Re: Blake Construction / Platt Res. / Lake City, FL

This letter is in reference to inspection issues on the above referenced project.

BONUS ROOM / GABLE END BRACING

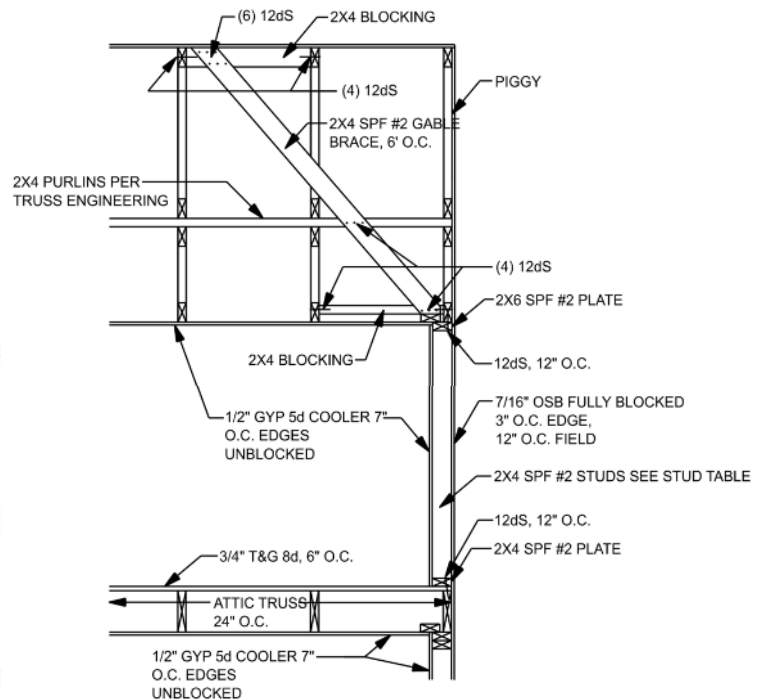
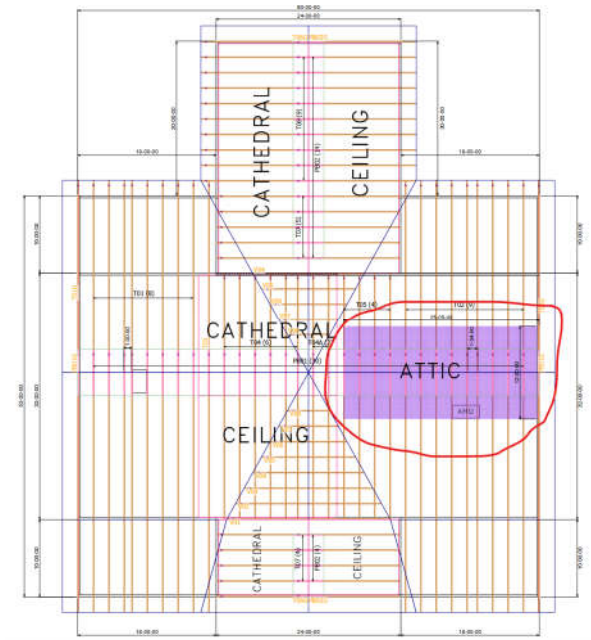
1. The builder changed the trusses to have a bonus room on the right side of the home. This is ok. Below is the new truss layout and the bonus room gable end bracing detail that should be used.
